MANAGEMENT REVIEW COMMITTEE KIF DREDGE CELL FAILURE - 2006

DETAIL C91

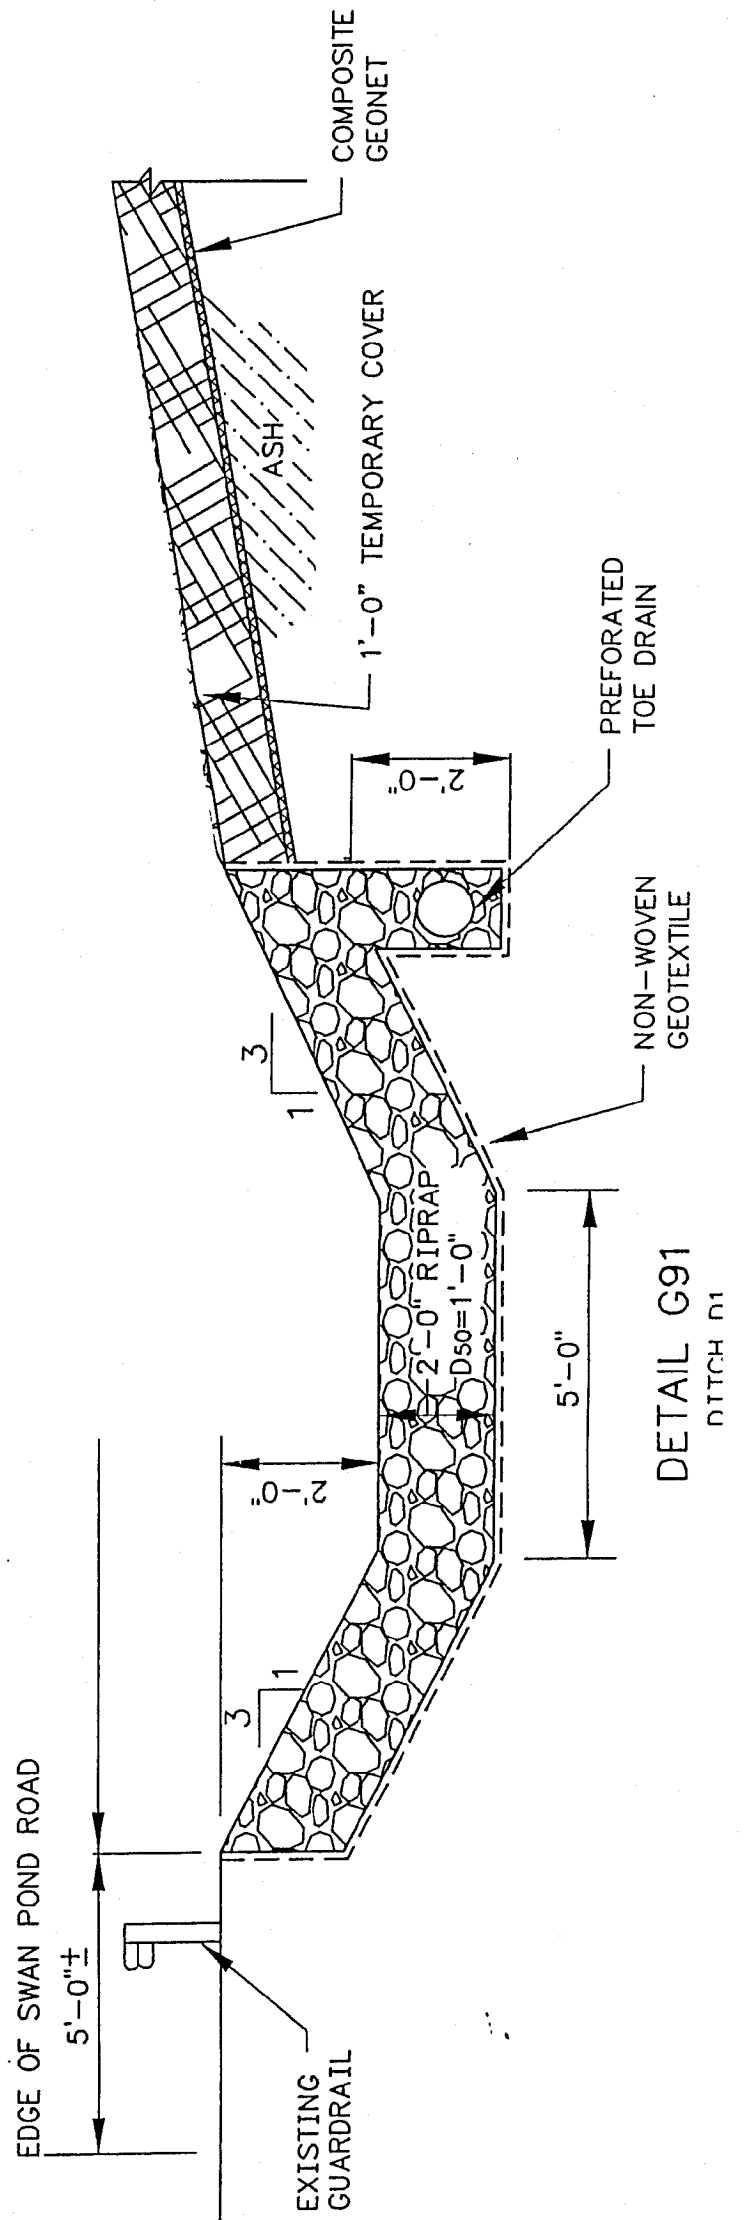
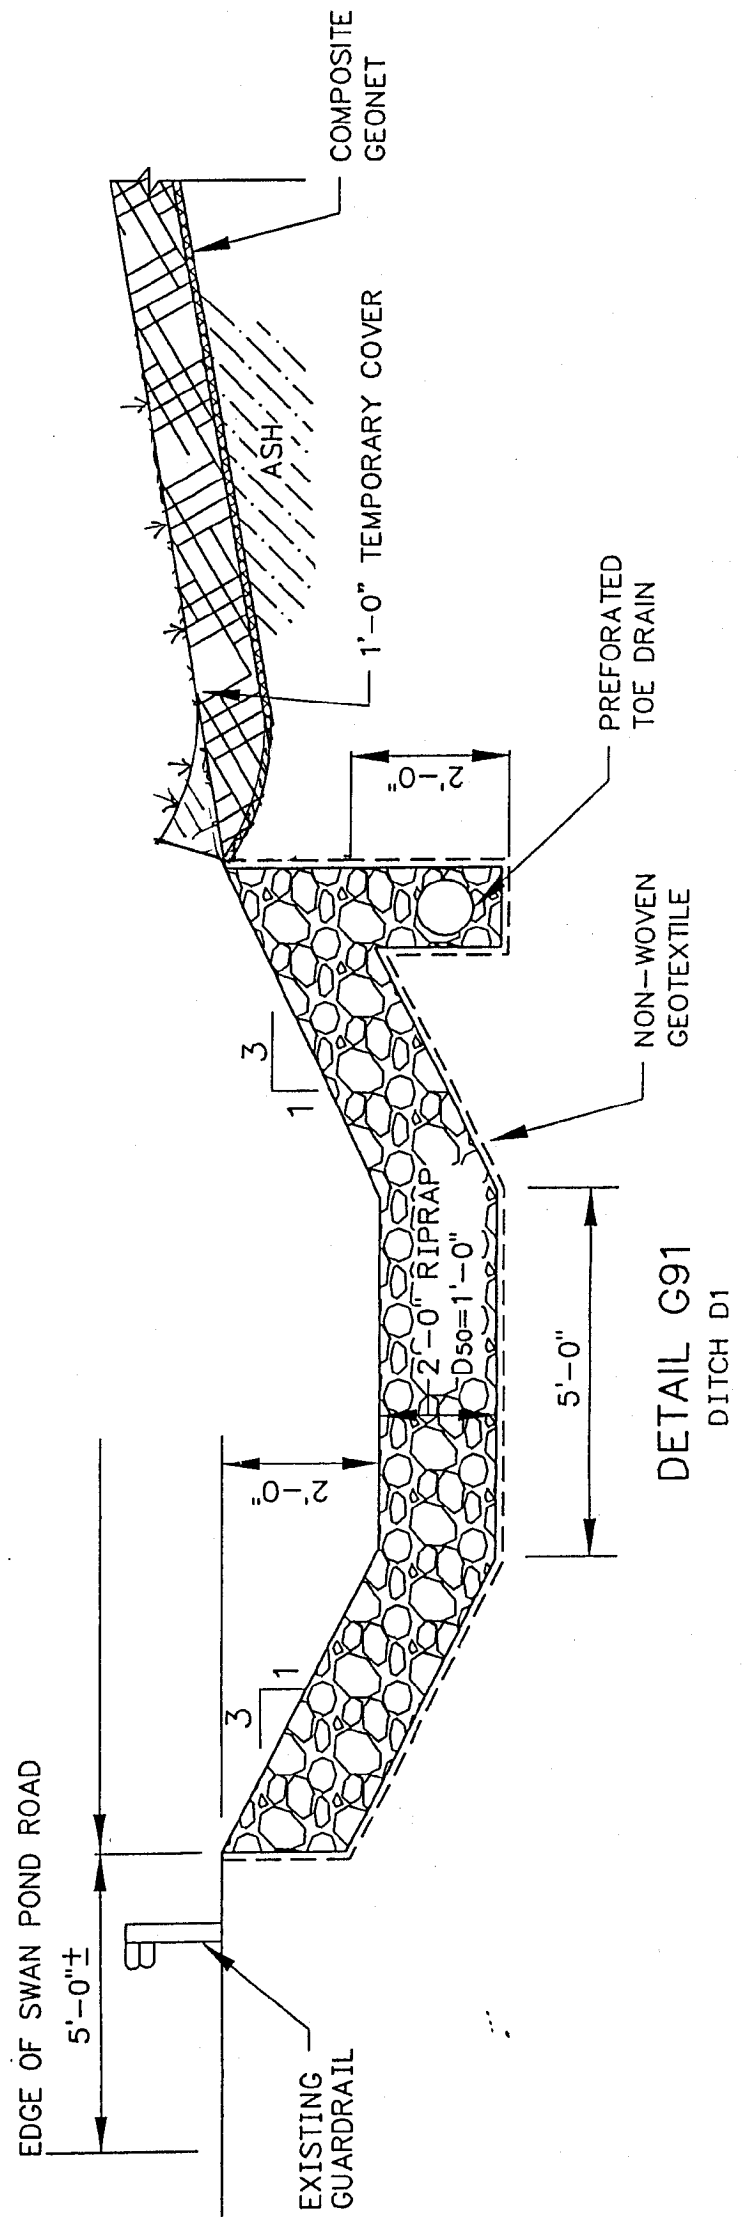
WHAT
SHOULD
HAVE
EXPECTED

WHAT
ACTUALLY
GOT
BUILT

MAY HAVE
BEEN BETTER

LAPPED AND LAYERED GEONET WITH FILTER FABRIC AT THE TOE WOULD HAVE BEEN A SUPERIOR DETAIL. BECAUSE THESE WERE PERMIT AND CONSTRUCTION DRAWINGS WE HAD TO COVER CURRENT AND FUTURE CONDITIONS. (AMBITIOUS TO DO IN ONE DETAIL) ALSO WOULD HAVE EXPECTED A STRONG FIELD ENGINEERING SERVICE TO PICK THIS UP. TWO "HOWEVERS" THOUGH. 1. THIS DONE DIFFERENTLY WOULD NOT BE SUFFICIENT TO HAVE CORRECTED FOR THIS MAGNITUDE OF LOCAL FAILURE. 2. HAD THIS BEEN DONE WE MAY NOT HAVE HAD AS EARLY AN INDICATION OF THE LOCAL PIPING UNTIL THE PROBLEM WAS MUCH BIGGER.
